# Replacement System Variance Request

Town of AUGUSTA

Permit No. 1312

System's Location: CHURCH HILL RD.  
Street

## SUBSURFACE WASTEWATER DISPOSAL PLAN

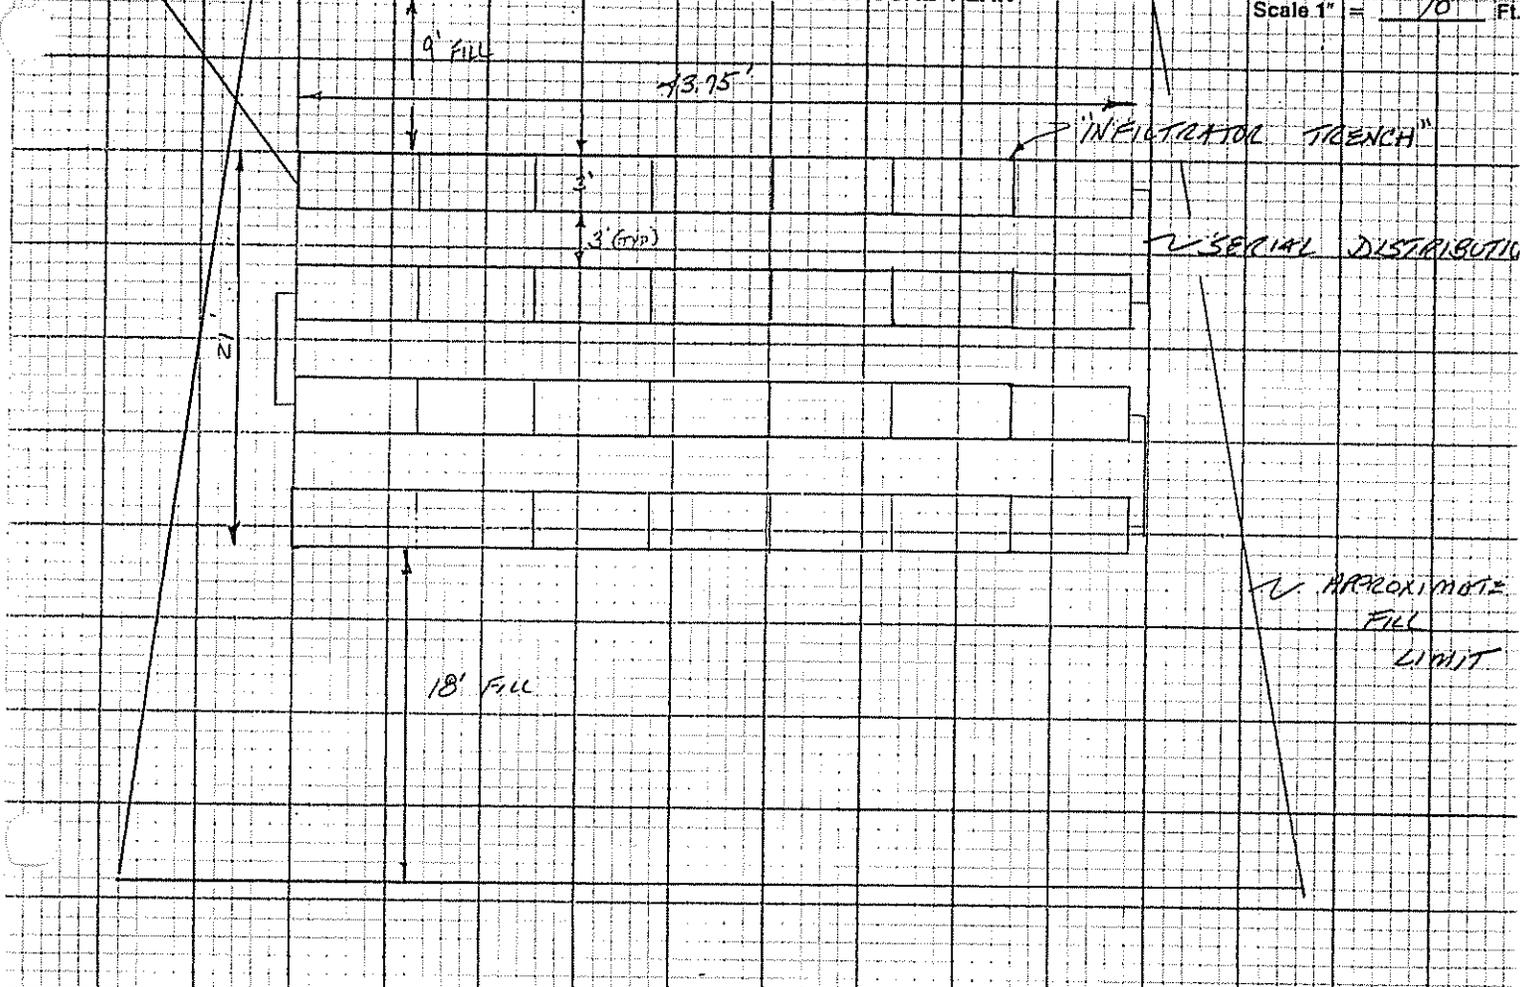
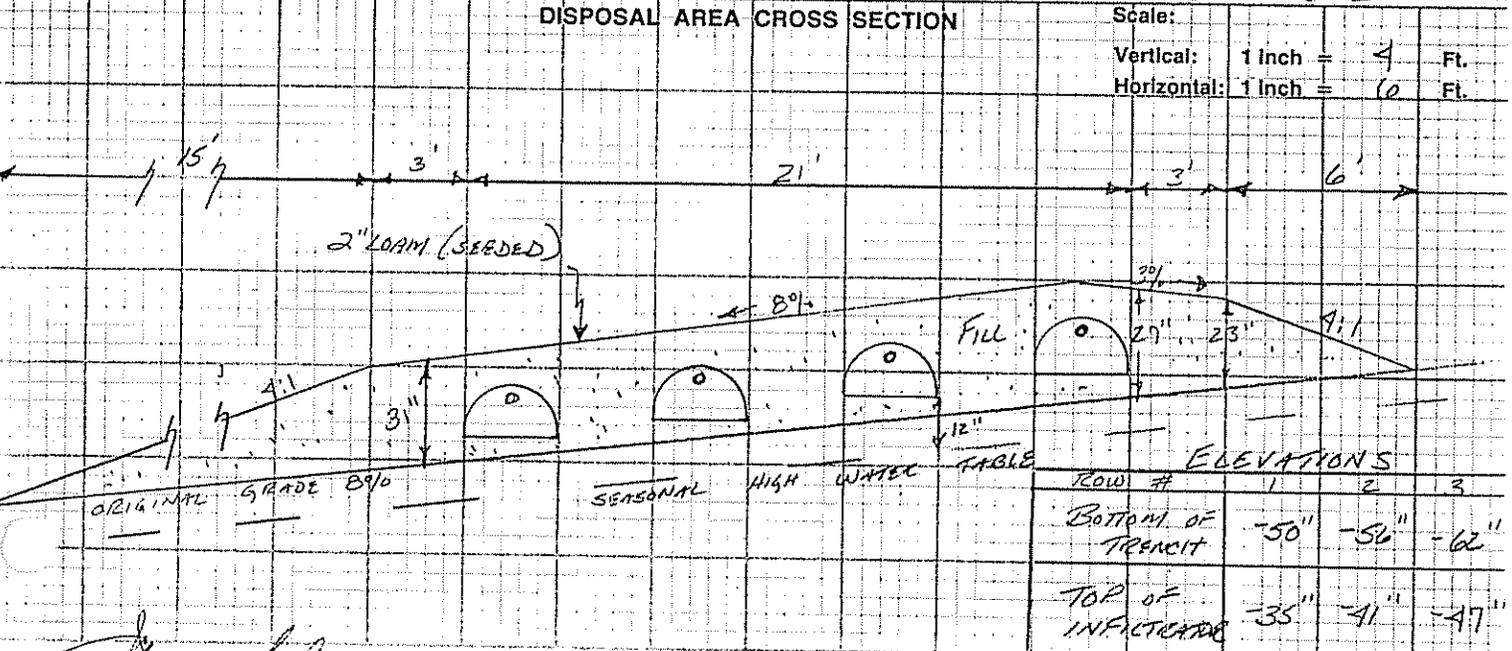
REDUCE FILL ON ROAD SIDE TO 3:1 & ENSURE FILL DOES NOT EXTEND INTO CITY RIGHT OF WAY VIA 5-4-88
